## 7300 TROUVILLE ESPLANADE TOWNHOUSES

DESIGN REVIEW BOARD MEETING  
JANUARY 4, 2022

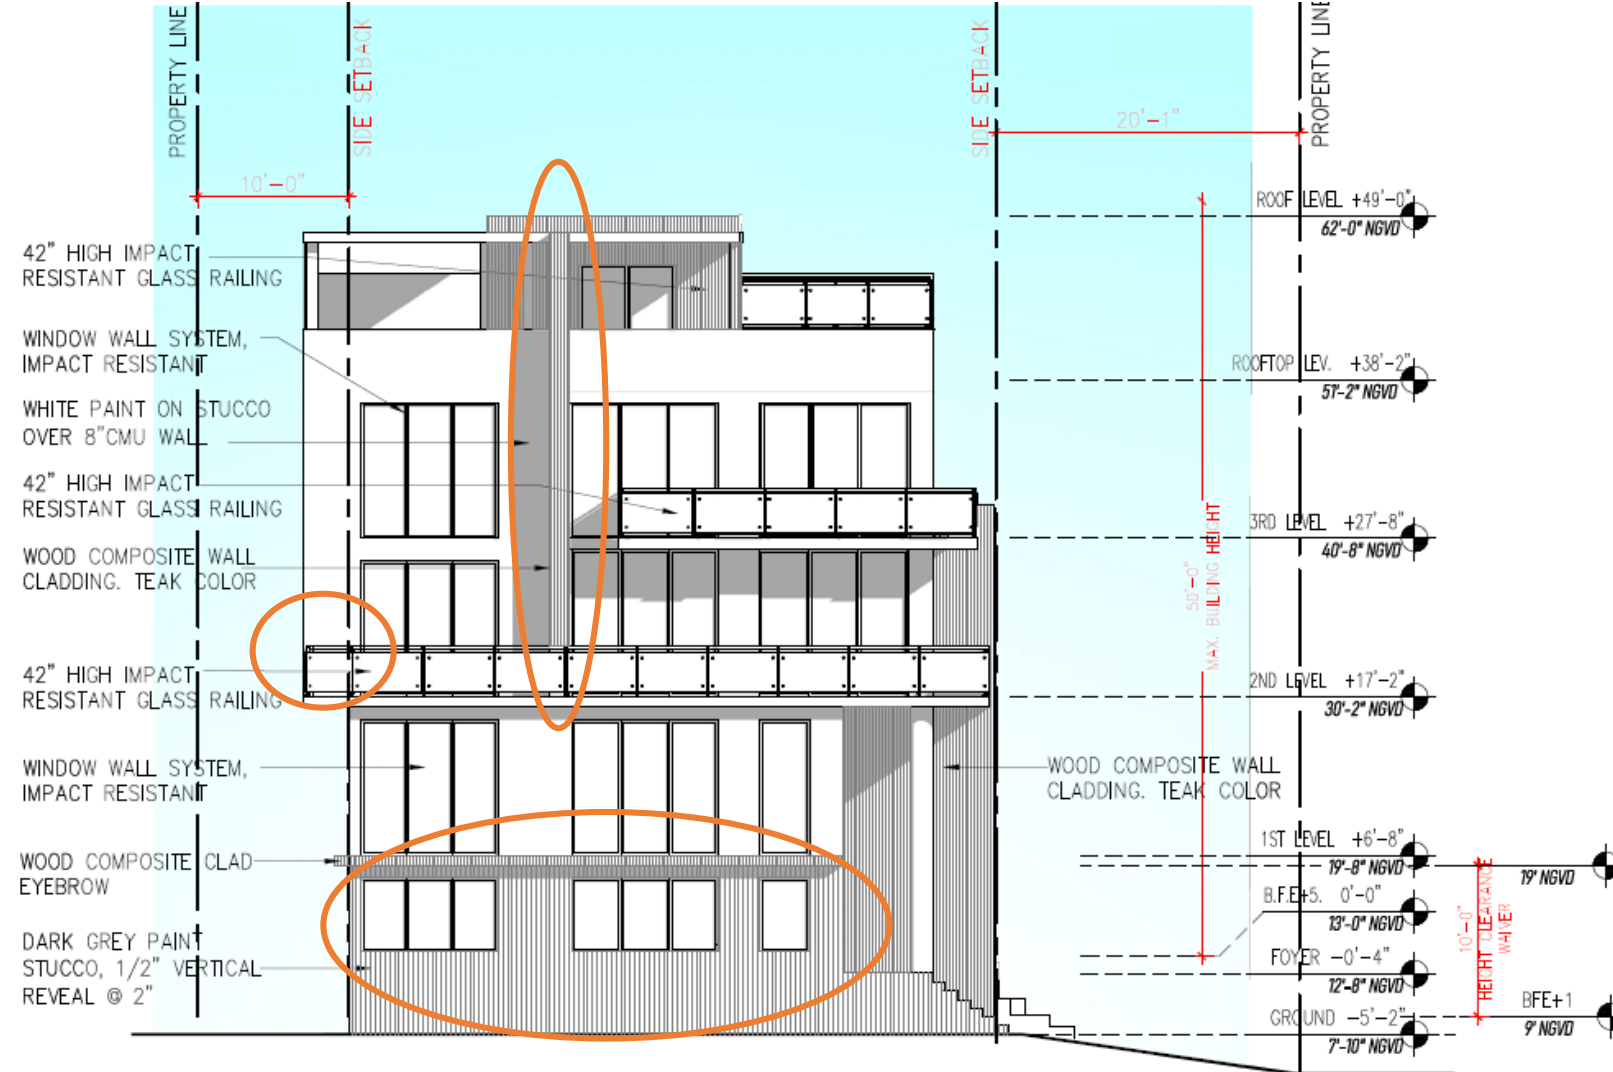
## REVISIONS PER STAFF COMMENTS:

- Increased landscaped areas
- Decreased all driveway widths to 11'-0"
- Pervious concrete pavers on driveway
- Overall reduction in Lot Coverage from 58.84%

SOUTH ELEVATION

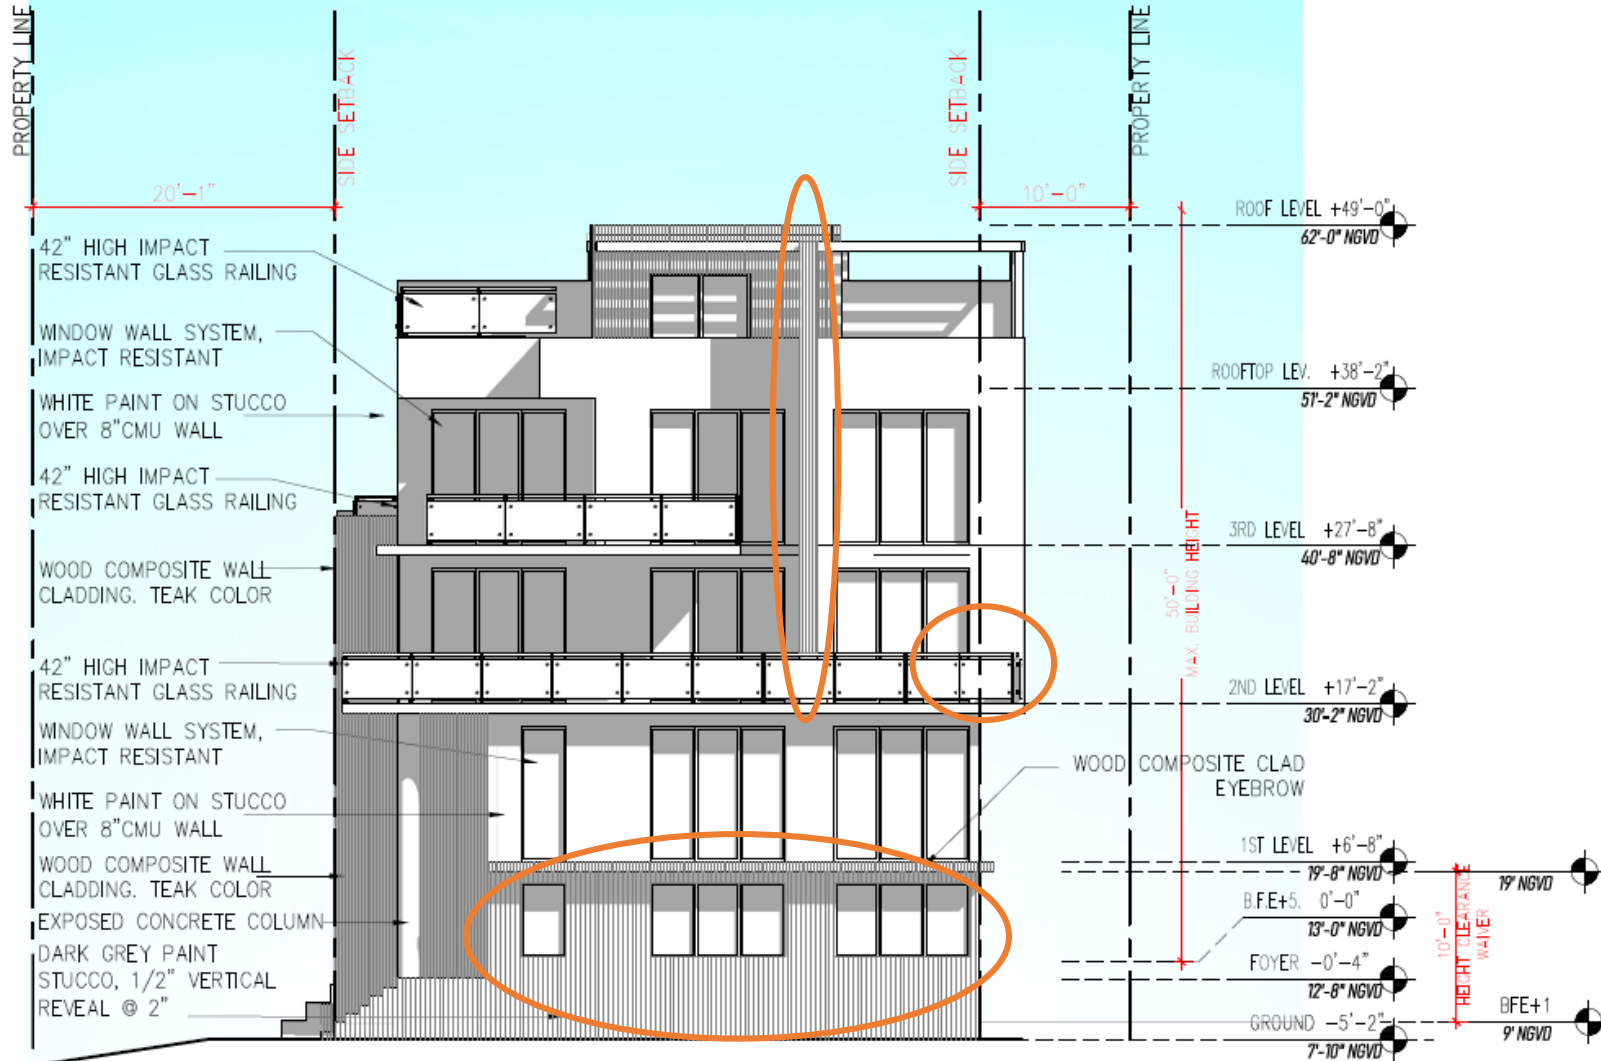
### REVISIONS PER STAFF COMMENTS:

- Extended balcony to improve south facade
- Added eyebrow treatment on ground floor for added symmetry
- Rearranged windows
- Added wood column & replaced material and ground level to diminish white stucco

NORTH ELEVATION

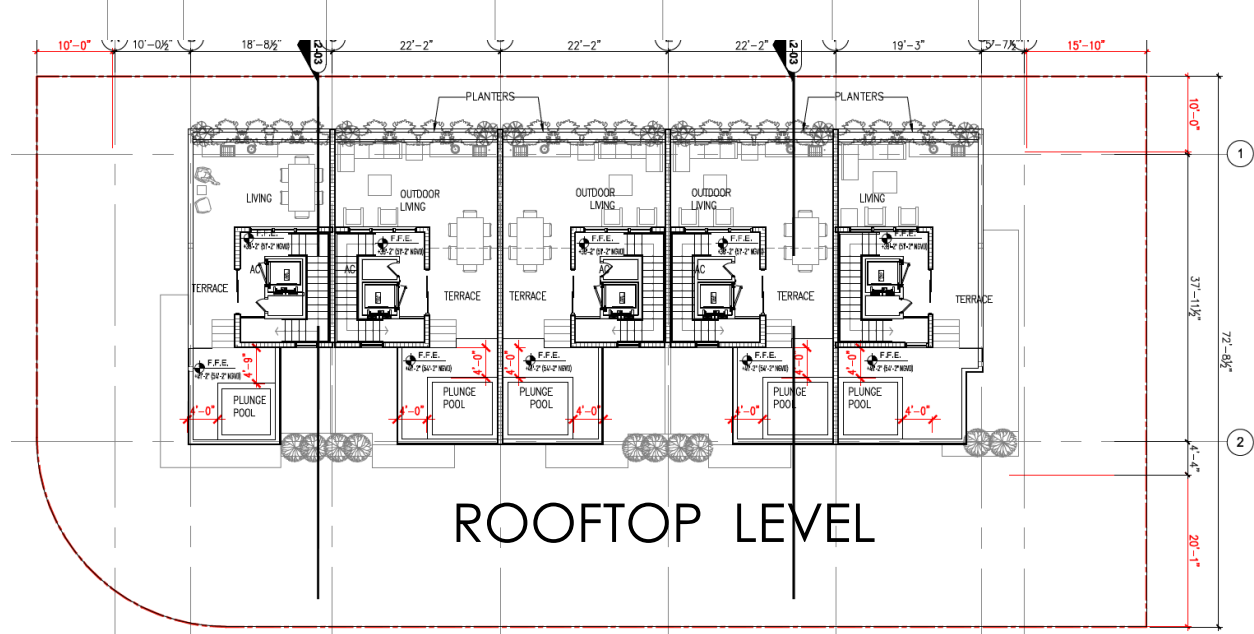
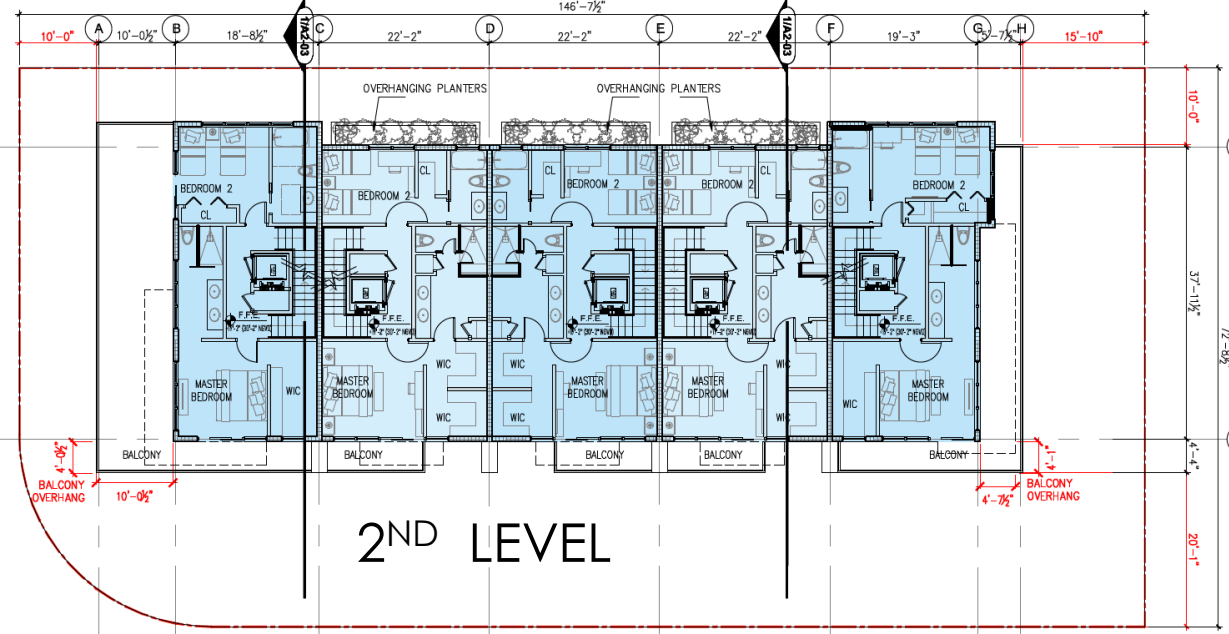
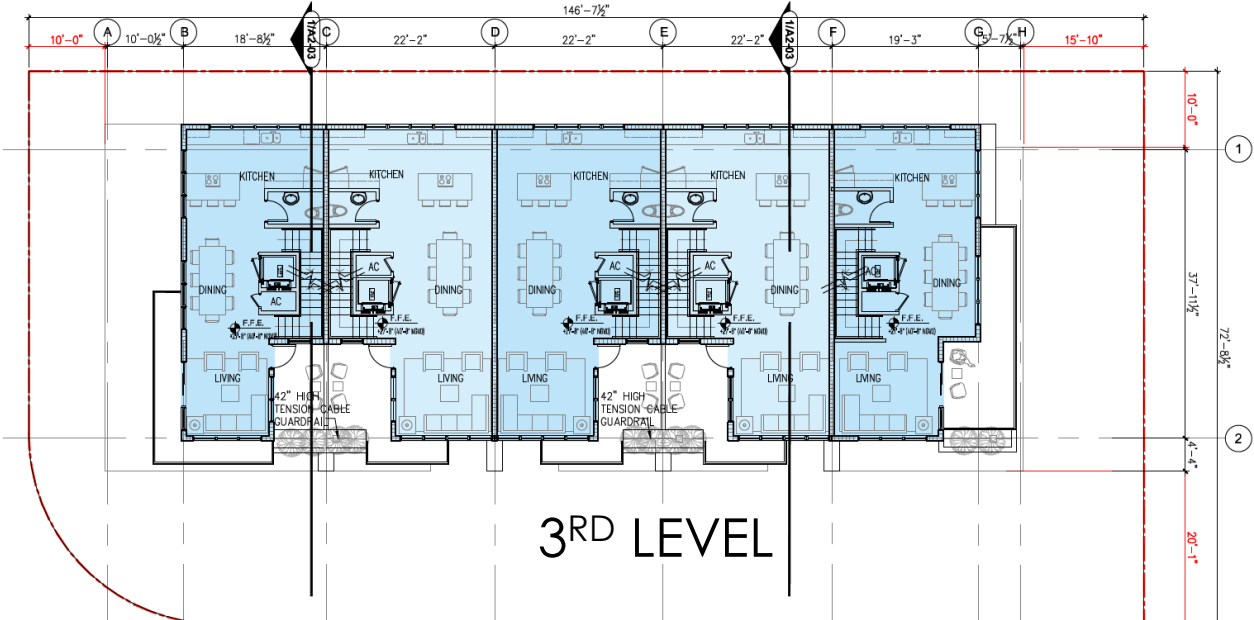
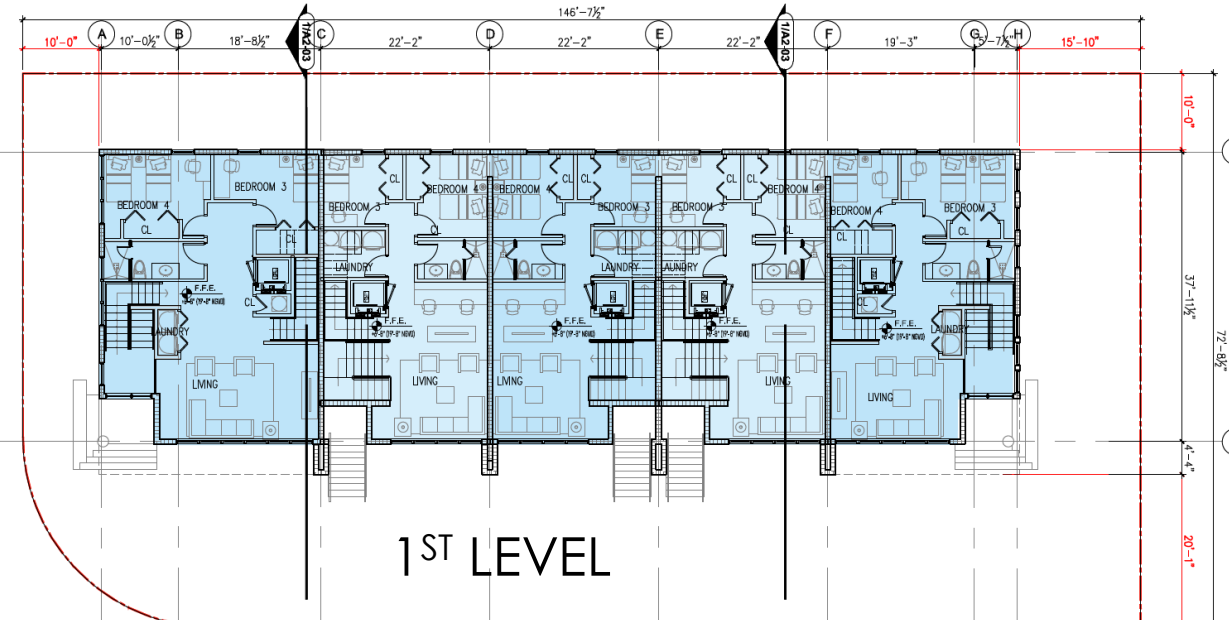
### REVISIONS PER STAFF COMMENTS:

- Extended balcony to improve south facade.
- Added eyebrow treatment on ground floor for added symmetry.
- Rearranged windows
- Added wood column & replaced material and ground level to diminish white stucco
